AMENDMENTS TO THE DRAWINGS:

Fig. 1

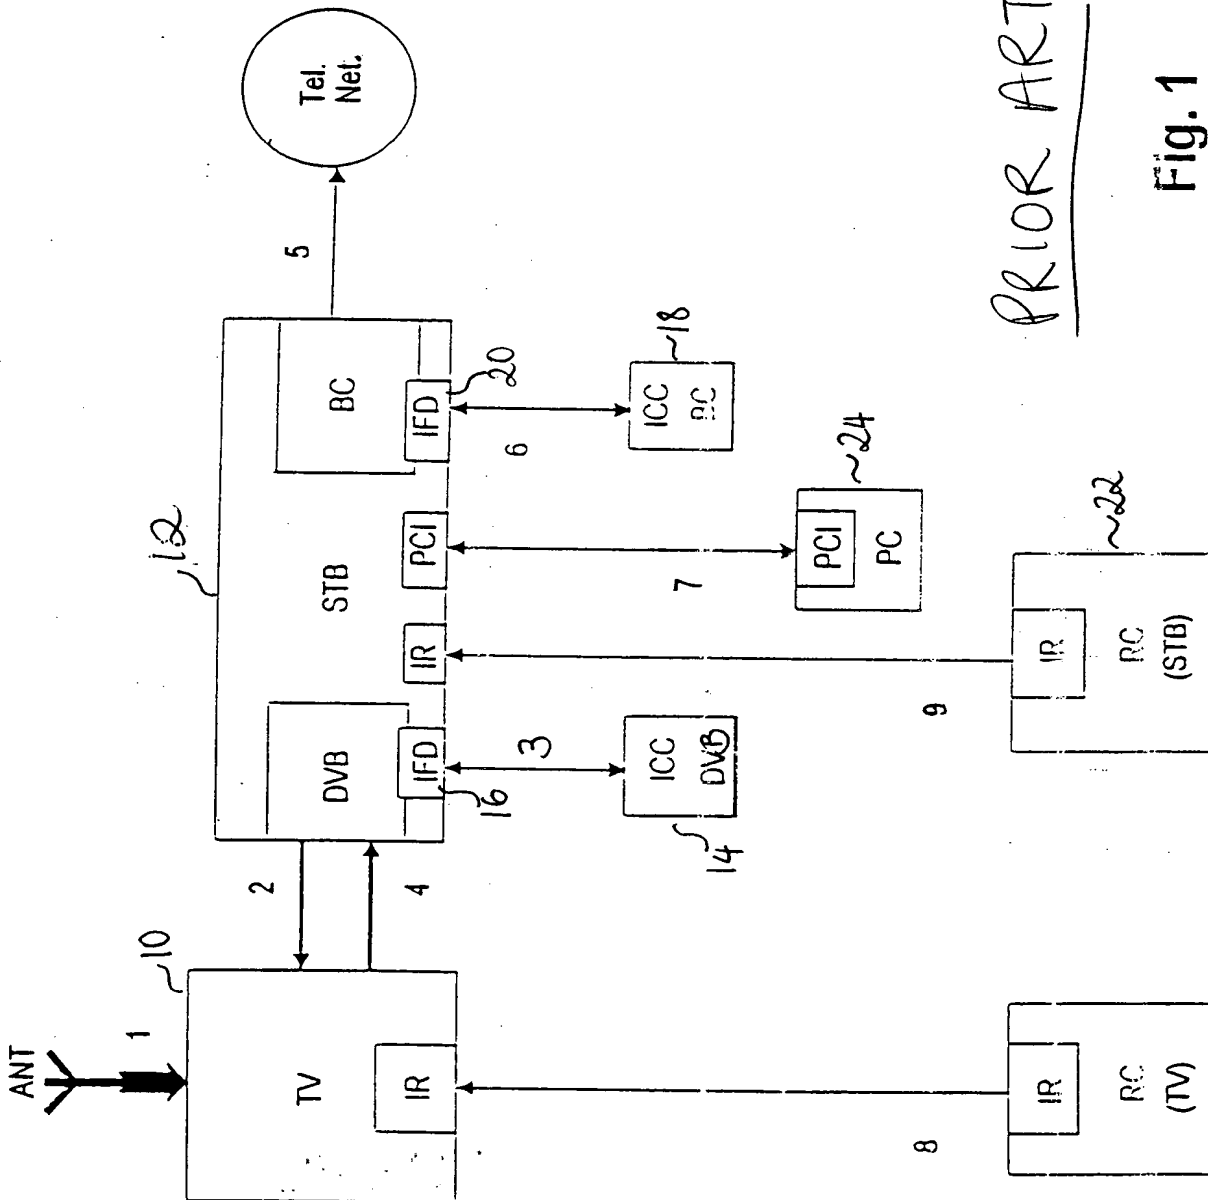
The attached sheet of drawings includes changes to Figs. 1 and 2. The sheets of Figs. 1 and 2 replace the original sheet of Figs. 1 and 2, respectively. In Fig. 1, STB “72” should read “12” in accordance with the Specification. Further, Fig. 1 should be labeled “Prior Art.” In Fig. 2, DVB “42” should read “45” in accordance with the Specification.

PRIOR ART
